**re:** **Geotechnical Review of Grading Plans**  
**Proposed Residential Development – Trails Edge – Stage 3**  
**298 Axis way – Ottawa, Ontario**

**file:** PG2392-MEMO.02

## **Grading Plan Review**

<p><b>PATERSON GROUP</b></p>	Title:	Scale:	
		<b>N.T.S.</b>	11/2025
		Drawn by: <b>NFRV</b>	Checked by: <b>DP</b>
			Drawing No.: <b>FIGURE 1</b>

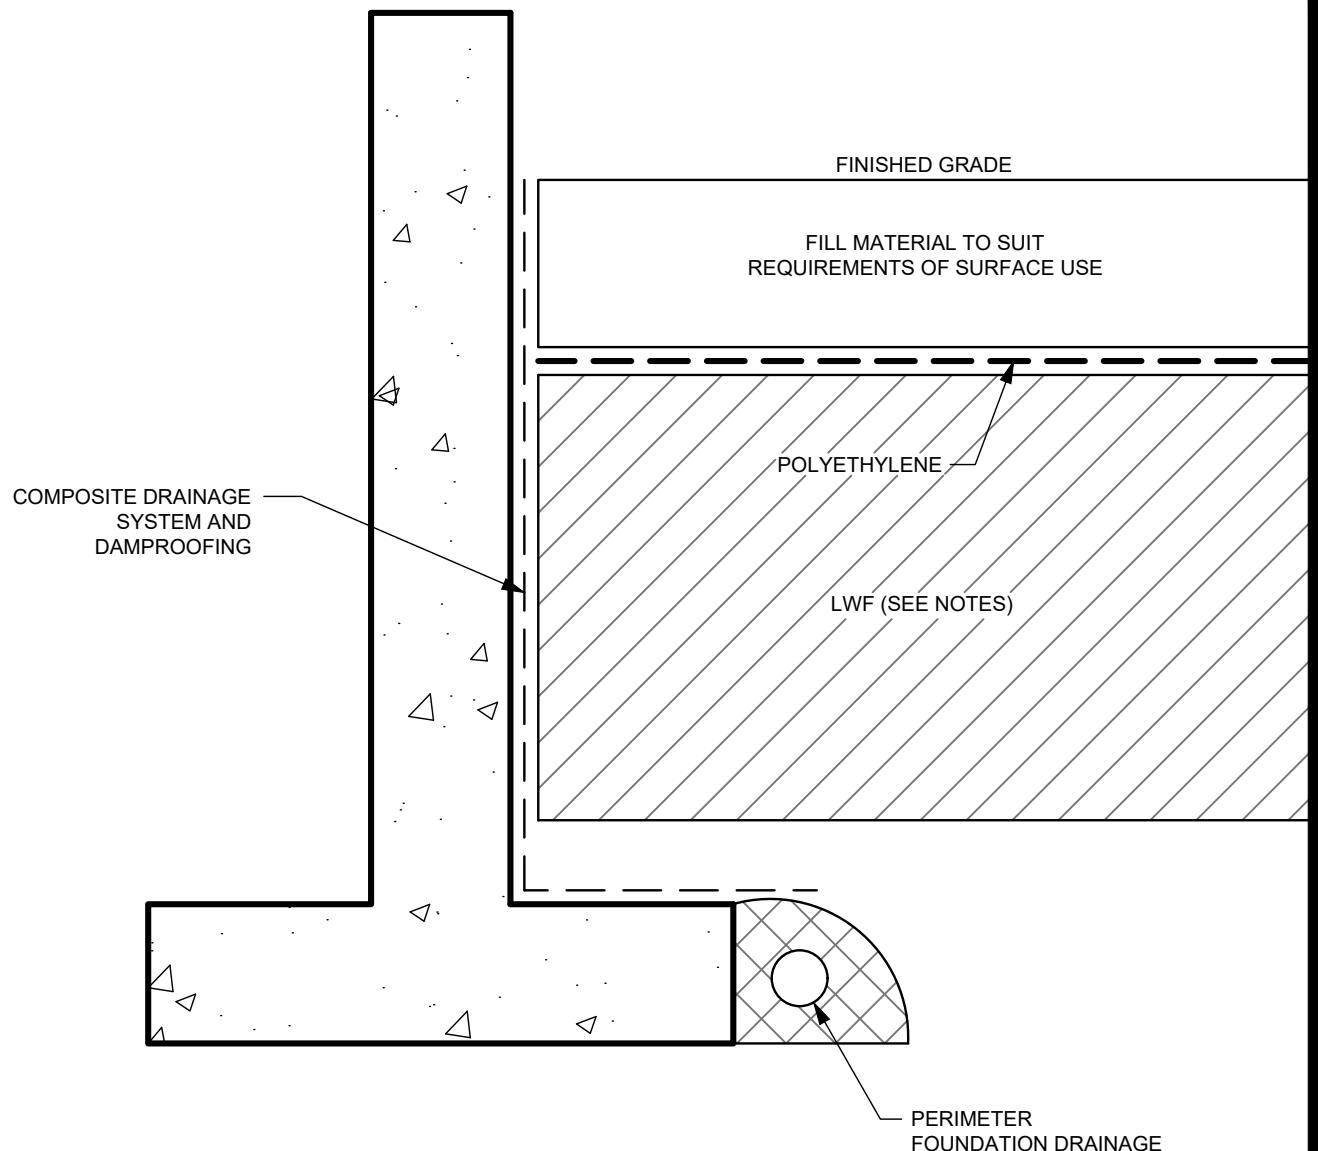
Based on our review of the above-noted drawing, a number of blocks/units of the subject site exceeded our permissible grade raise recommendations provided in the above-noted geotechnical report. Where significant grade raise exceedences have occurred, lightweight fill (LWF), such as expanded polystyrene (EPS) geofoam blocks are recommended for specific areas adjacent to the subject buildings. It should be noted that the proposed roadway grades throughout the subject site were found to be within the recommended permissible grade raise restrictions for roadways provided in the aforementioned geotechnical investigation report. Further, sufficient soil cover has been provided to perimeter and exterior pad footings to mitigate the migration of frost within the founding subsoils.

1. USE EPS12 BELOW FRONT PORCH AND LANDSCAPED AREAS
2. USE EPS15 BELOW GARAGE AND DRIVEWAY
3. MINIMUM GRANULAR THICKNESS OVER LWF SHOULD BE AS FOLLOWS:

FRONT PORCH	150mm OF OPSS GRANULAR A
GARAGE	300mm OF OPSS GRANULAR A
DRIVEWAY	450mm OF OPSS GRANULAR A
LANDSCAPED	500mm OF APPROVED BACKFILL SOIL
4. PLACEMENT OF LWF SHOULD BE ON A LEVELED SURFACE (SAND CAN BE USED TO PROVIDE AN ADEQUATE LEVELLING SURFACE).
